### Q12.1.11 Missing Archaeological Fieldwork

Plan from APP-369 – National Highways: Scheme wide Written Scheme of Investigation for Trial Trenching south of the River Thames

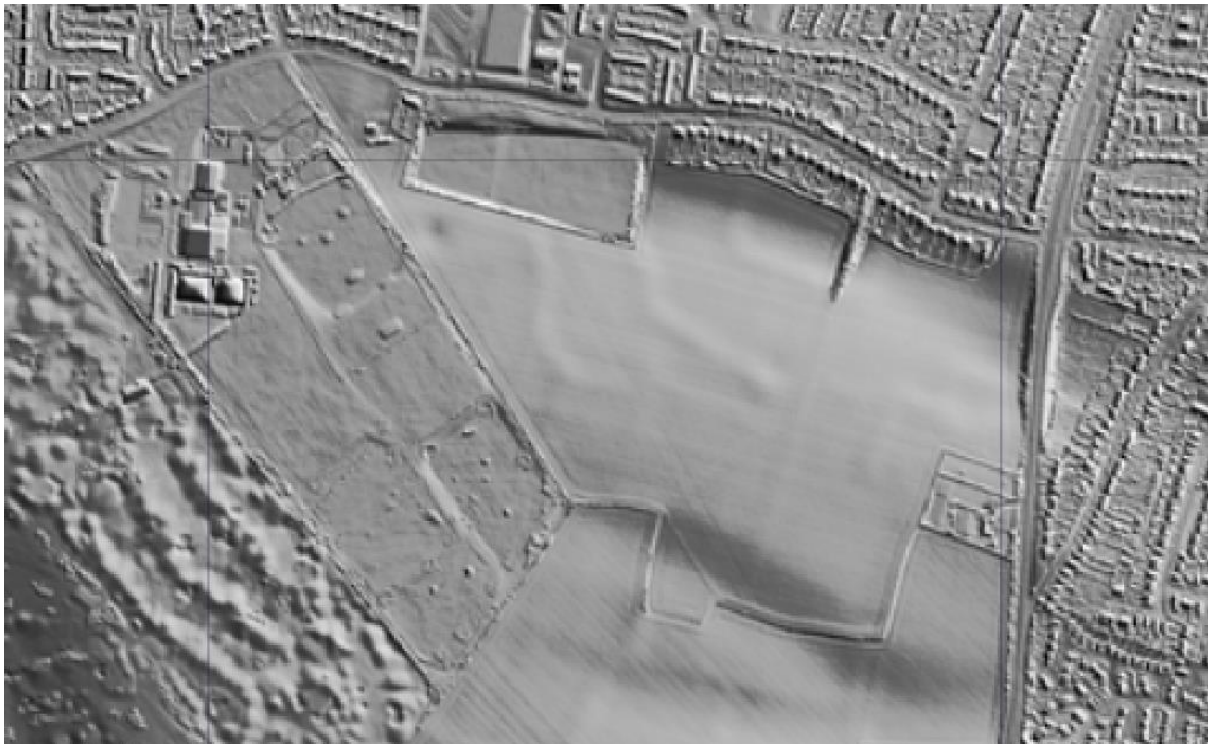
Whilst GBC would defer to the expert advice of KCC when it comes to archaeology, this is an outstanding issue that was raised with the applicant at the Statutory Consultation stage in 2018. The area of concern broadly corresponds with parcel 85 on the plan below, within which it is understood that trial trenching was not undertaken prior to submission. Neither the Geophysical Surveys (APP-360 + 361) or the Trial Trenching Reports (APP-362 to 366) appear to cover this area.

Plans submitted with the application identify extensive archaeological targets within this area (APP-185 and APP-186), ranging from pre-historic, iron age and Roman, to medieval. The evolution of this part of the site is therefore complex and interesting and presumably has a relationship with archaeology (that has been subject to detailed investigation through trial trenching etc) to the east.

All GBC is suggesting therefore is that sufficient flexibility be built into the dDCO to allow for preservation of archaeology in-situ, in a way that is commensurate with its significance and that the final design and layout of the construction site/Chalk Park only be agreed once the necessary archaeological fieldwork has taken place and the results reviewed by KCC archaeology.
